# ADDENDUM No. 1

ITB No. 4736

## GALLUP PARK VEHICLE AND PEDESTRIAN BRIDGE

PLAN

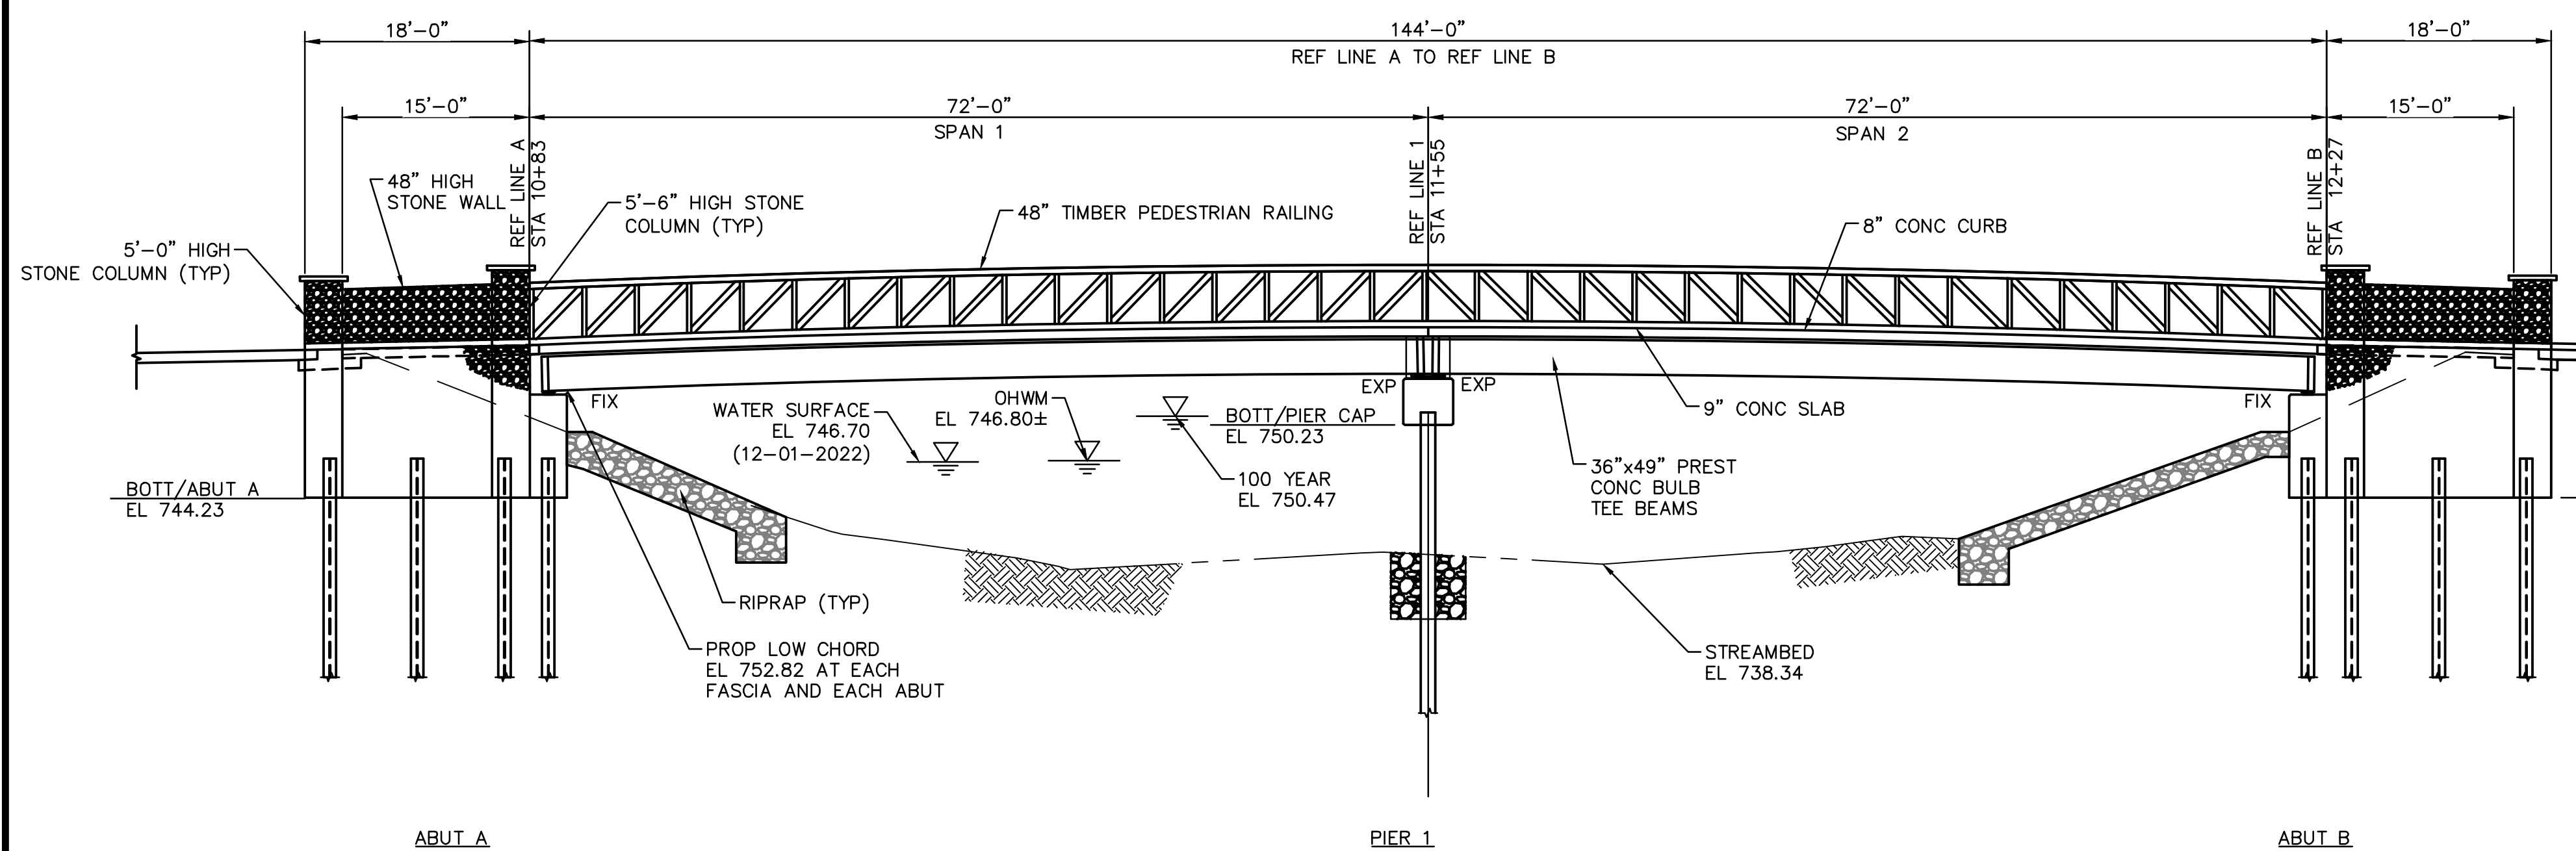
Sheet 28 of 55: Added the following pay items:

- Cofferdam; 1 LSUM
- Erosion Control, Turbidity Curtain, Deep; 380 Ft
- Contractor Staking; 1 LSUM

- Question 9: No item on the bid form for cofferdams exists. How are we expected to price this? Will this be added to the bid form as an addendum?  
Answer 9: The pay item, "Cofferdam" has been added to the bid form as part of Addendum #1. This pay item has also been added to the Misc. Quantities box on Sheet 28 of 55.

Answer 10: The pay item, "Turbidity Curtain, Deep" has been added to the bid form as part of Addendum #1. This pay item has also been added to the Misc. Quantities box on Sheet 28 of 55.

CITY OF ANN ARBOR - COMMUNITY SERVICES - PARKS AND RECREATION  
GALLUP PARK VEHICLE AND PEDESTRIAN BRIDGE  
DESIGN - BRIDGE REPLACEMENT PLANS  
PILE DETAILS

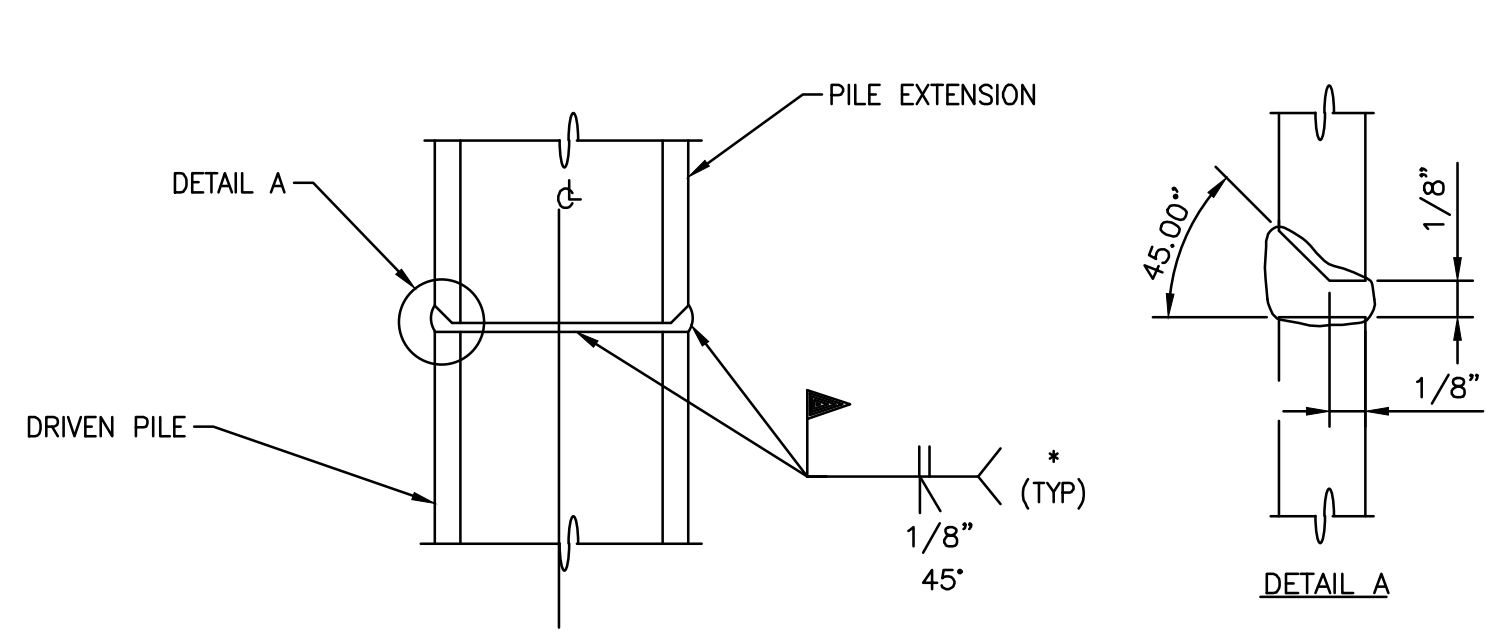
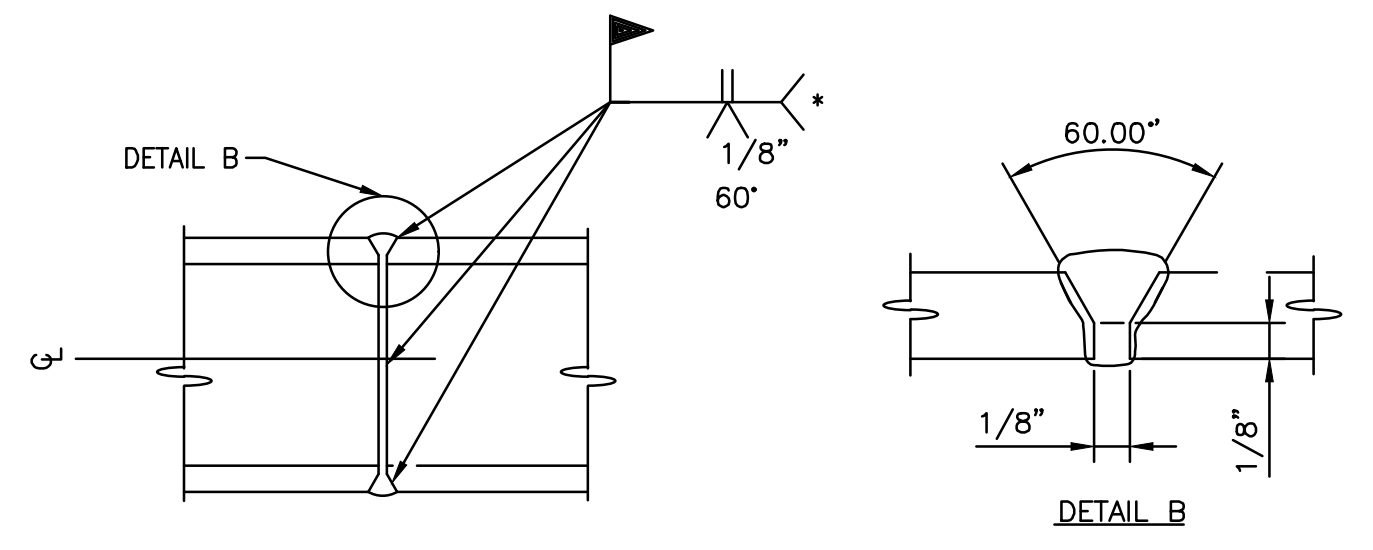
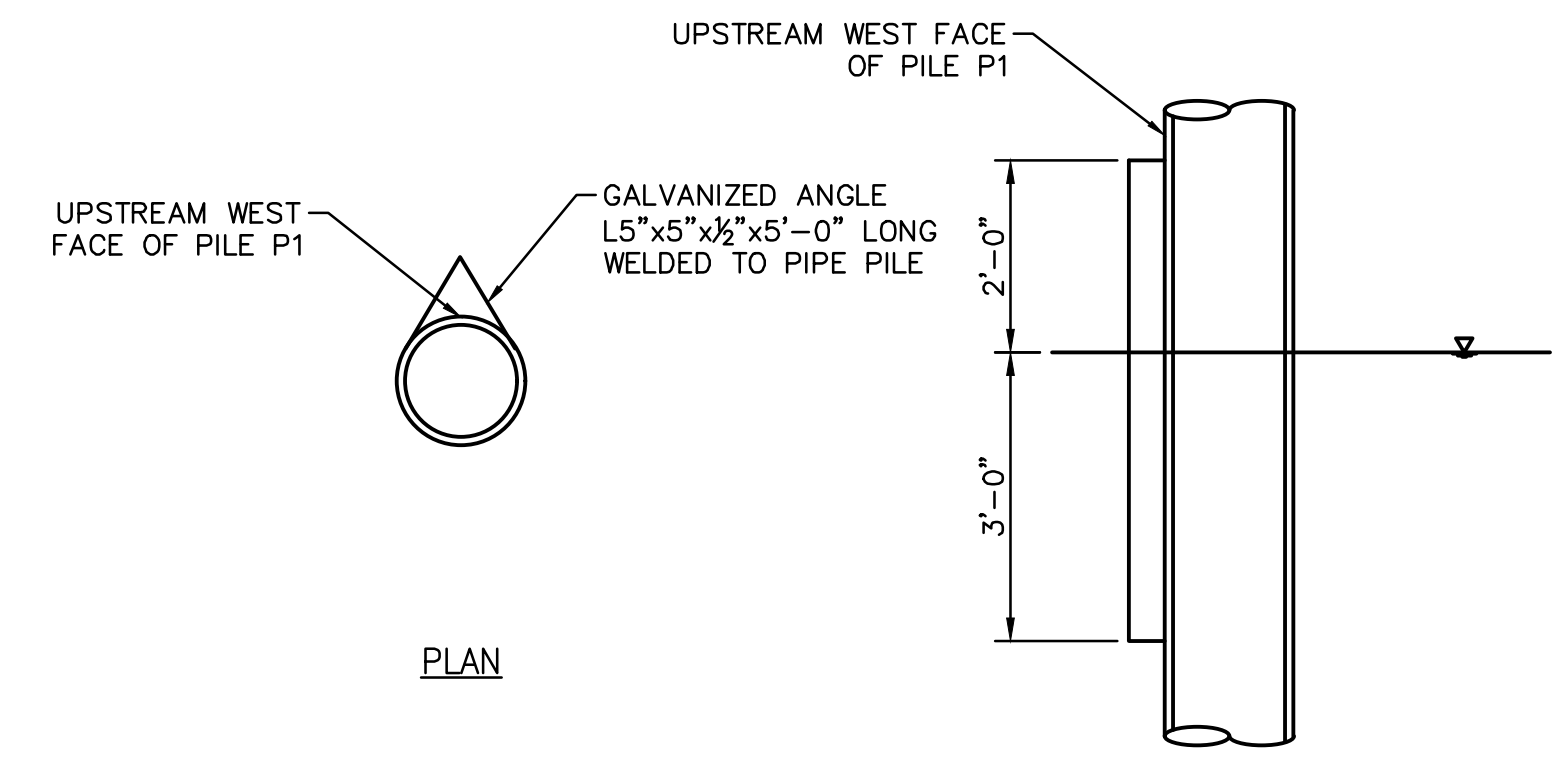
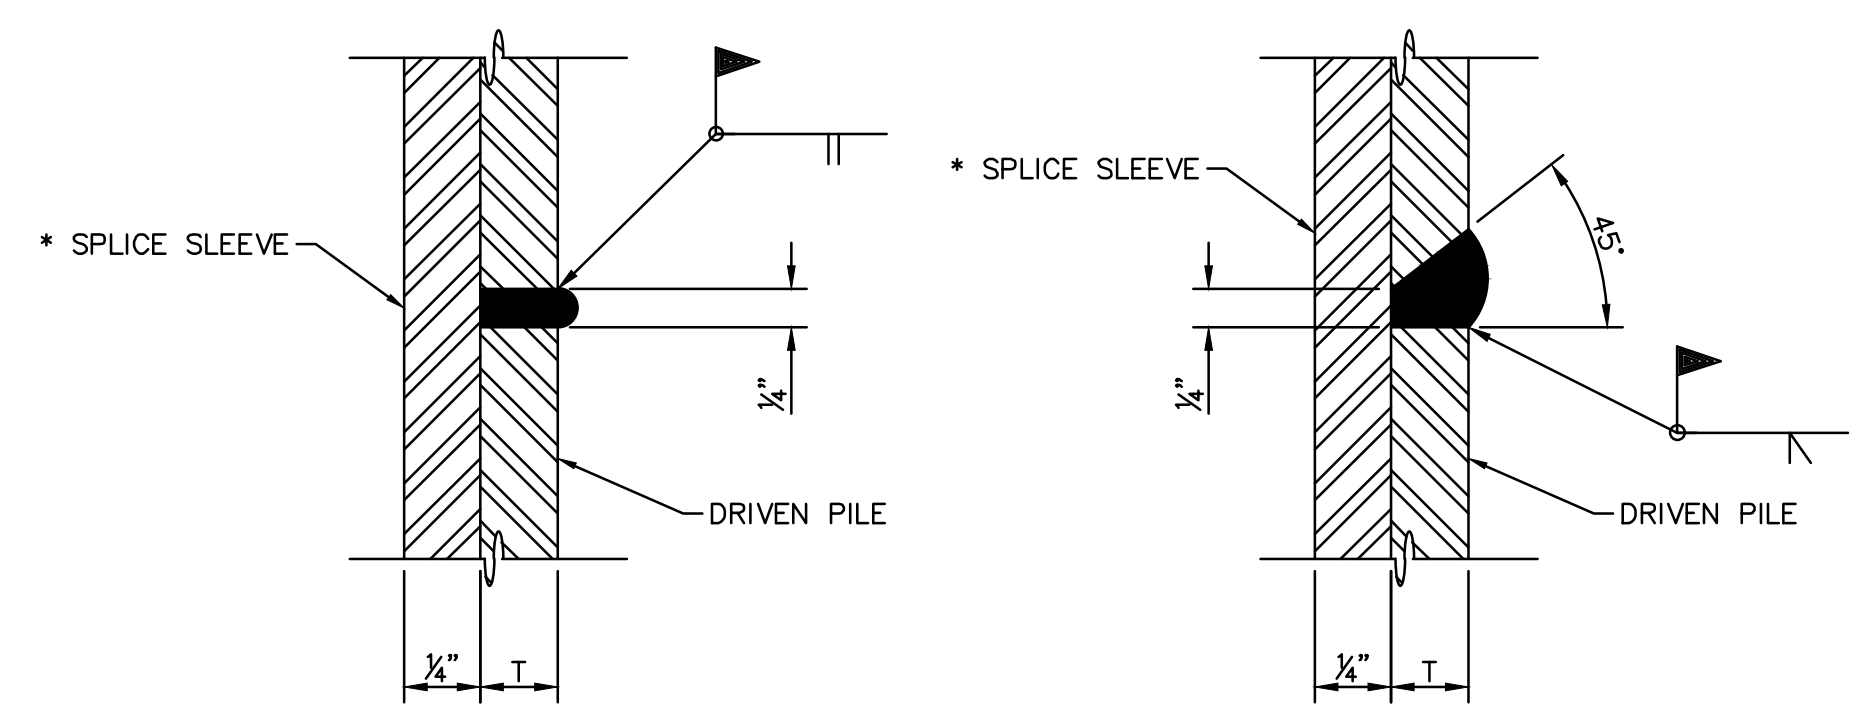
Sheet 32 of 55: Added notes that clarify:

- Galvanizing the CIP Piles at center pier
- CIP Pile Points per MDOT BDG 8.21.03
- Contractor utilizing soft digging techniques for utilities.

- Question 11: There is a bid item "Pile, Galv" which is a lump sum item, but the piles to receive this treatment and the limits on each pile are not defined. Can the locations and limits of the galvanizing of the piles be clarified?

Question 18: There was no detail for a pile point for the CIP piles, is there a particular pile point desired for these piles?

Answer 11: The galvanized piles are to be the 16-inch diameter piles at the pier only. The limits of galvanizing are to be from pile cut-off elevation to bottom of river (+/- El 739.0)

Answer 18: Pile point for CIP piles are to be per MDOT BDG 8.21.03
